Doosan Infracore
Portable Power

Service Letter

SL: 40025
Date: 12 April 2012
Product: Compressors
Subject: Discharge Hose

Figure 1

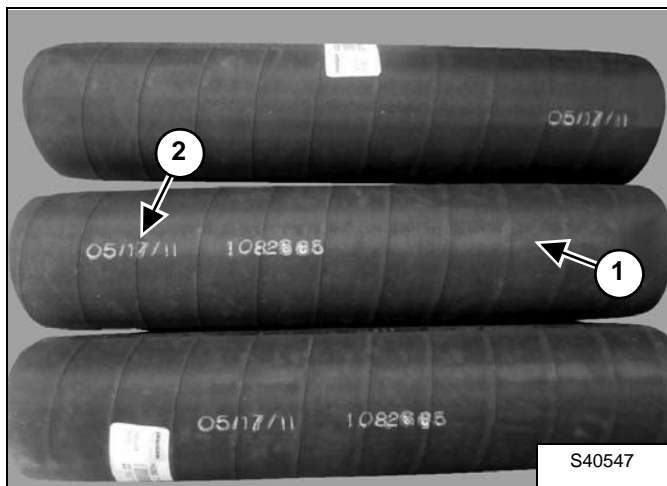
Doosan Infracore has determined that there could be oil leakage on the compressors listed in this letter due to inner liner separation of the rubber discharge hose (item 1) [Figure 1] between the air end and separator tank.

Inspect the discharge rubber hose section for having date code 05/17/11 (item 2) [Figure 1] ink stamped on the hose.

Replace any hose that has the 05/17/11 date code or that has no code, either on the machine, or in the customer, or end user inventory, according to the procedure outlined below.
